Request for Proposal (RFP)
Bid No: Bid 26-05-4136SB
Addendum No. 2

Date: June 12, 2026
To: All Proposers
Subject: Addendum No. 2
Consisting of Nineteen (19) Pages
RFP No.: Bid 26-05-4136SB
Project Name: N9073(1)1,2&4 Blue Canyon Road Project in Apache County, AZ
Owner: Navajo Division of Transportation

Addendum No. 2

N9073(1) 1, 2 & 4
 PERMANENT & TEMPORARY
 TRAFFIC CONTROL DETAILS

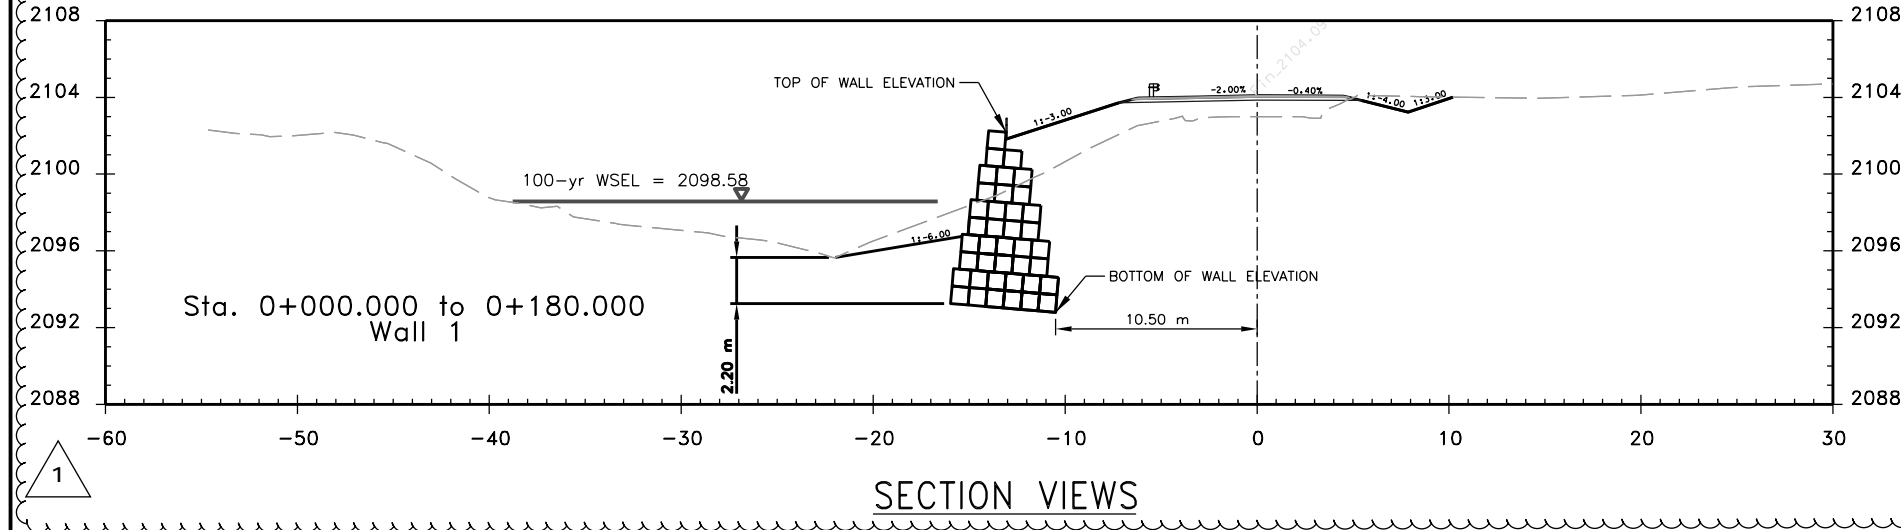
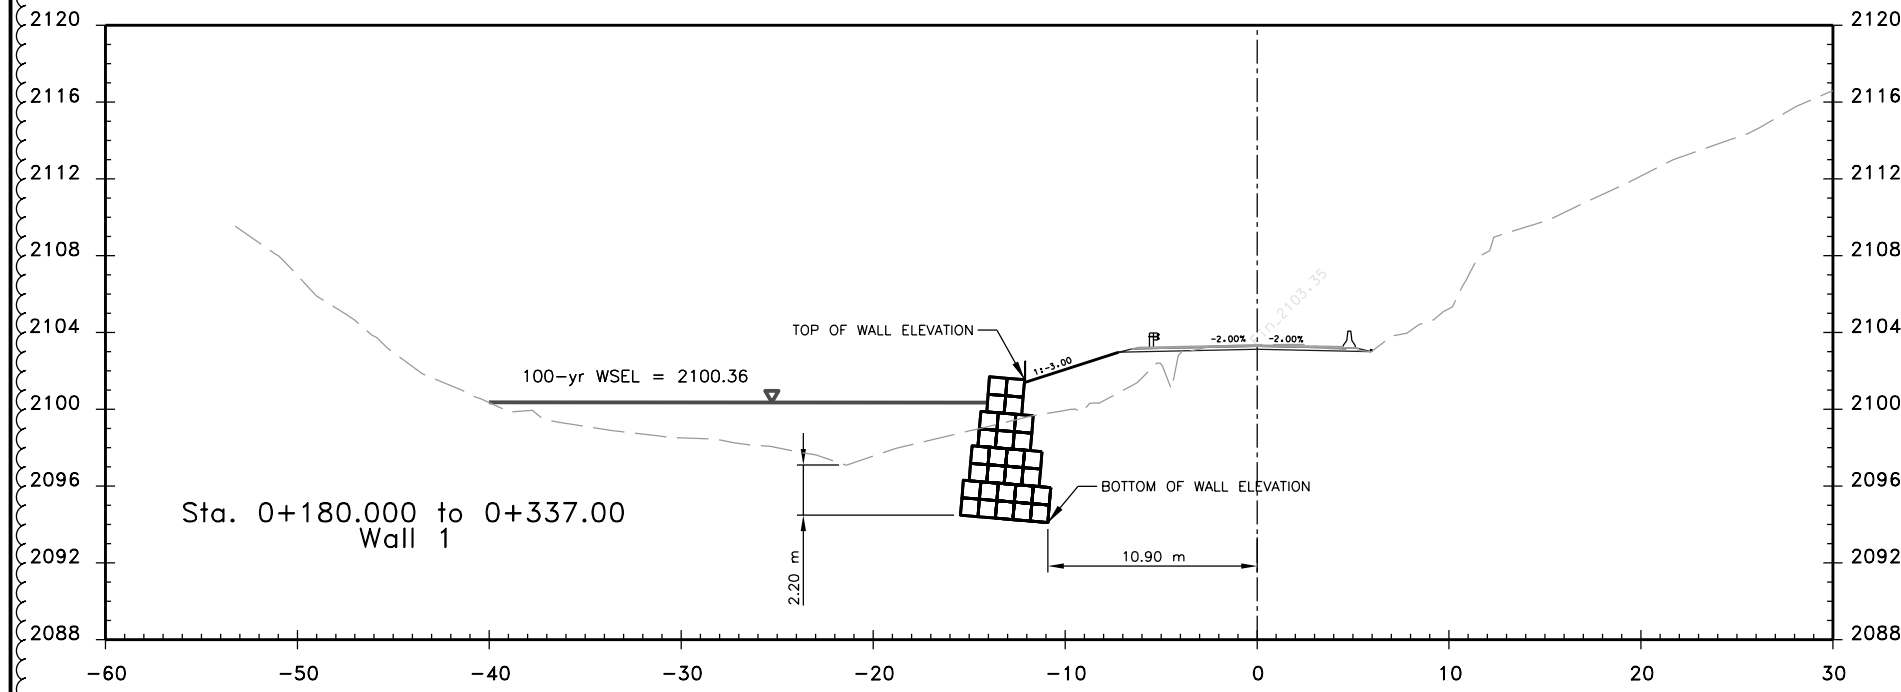
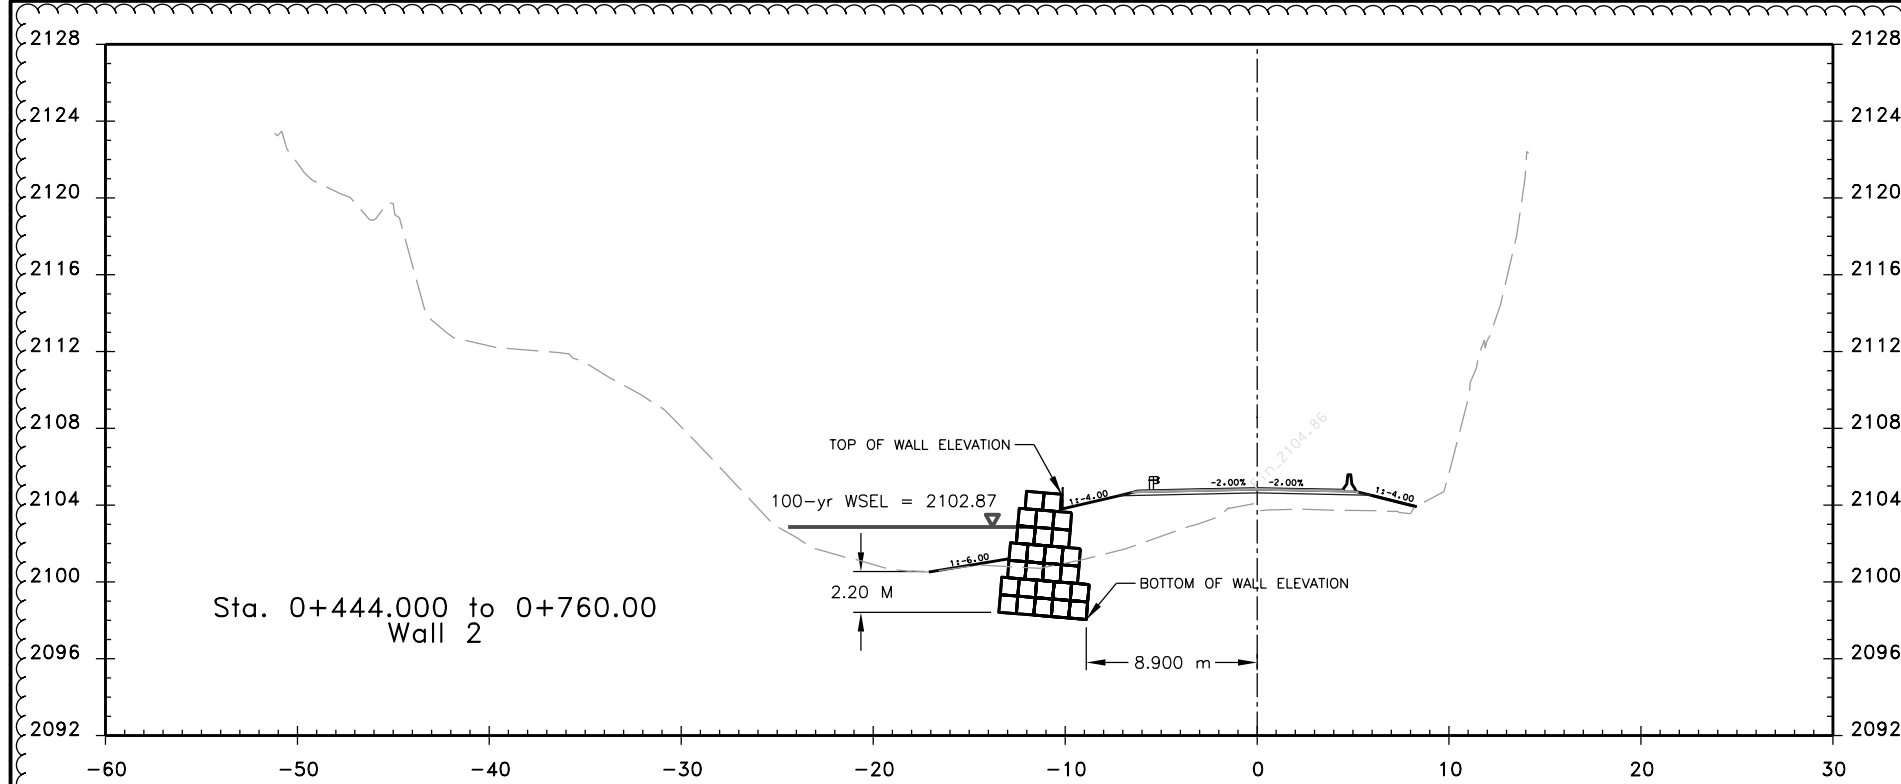
- Sheet 7 ESTIMATED QUANTITIES TABLES: Revised to remove Bid Item No. 63302-2012 and revised to update the quantity for Bid Item No. 63301-2001 from 10 m² to 23 m².
- Sheet 28 PERMANENT & TEMPORARY TRAFFIC CONTROL DETAILS: Revised to remove Bid Item No. 63302-2012.
- Sheet 33A GABION WALL CROSS SECTION TABLE & GENERAL NOTES: Revised to remove the pedestrian railing on gabion wall.

1 DELETED PED HANDRAIL	MKC	6/11/26
REVISION	BY	DATE
 NAVAJO D.Q.T. N9073(1) 1, 2 & 4		
GABION WALL CROSS SECTION TABLE & GENERAL NOTES		
PROJECT MANAGER: DDM	DATE: 1/22	DRAWING
LEAD DESIGNER: MLL	DATE: 1/22	SHEET
ASBUILT BY:	DATE: xxx	
SCALE: N/A		33A OF 83

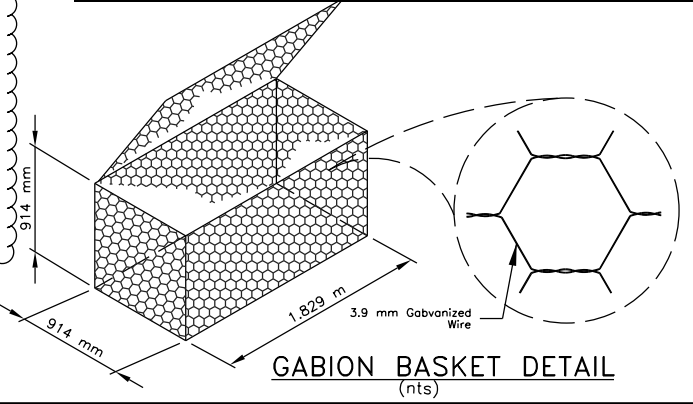
<p>Plan sheet 33A of 83 shows pedestrian rail at the top of the gabion baskets.</p> <p>Would NDOT provide a detail for this handrail, and clarify how it is paid?</p>	<p>The detail on Sheet 33A was revised to remove the handrail.</p>
<p>For the callouts “C900 HDPE Pipe Wash Crossing” should we be transitioning from PVC to HDPE in these areas?</p>	<p>The “C900 HDPE pipe” was a typing error.</p> <p>The NTUA specifications require that HDPE pipe be used for wash crossings. The project requires that the 200 psi, SDR 21 PVC waterline pipe transition to HDPE pipe through wash crossings, then back to PVC.</p>
<p>Typically NTUA specs want IPS Class 200 SDR21 pipe but the plans callout for C900 DR18. Should we follow the plans or typical specs?</p>	<p>The “C900 pipe” was a typing error. Follow the NTUA specifications. Use IPS Class 200 SDR 21 pipe.</p>
<p>On Sheet 78 there is a callout for a 10” cap that is pointing at the center line of construction, is this cap needed?</p>	<p>Yes, there is a 10-inch cap to the existing waterline in this area. The existing 10-inch waterline is to be capped. (The existing 10-inch AC waterlines are to be filled with grout and abandoned in place.)</p>
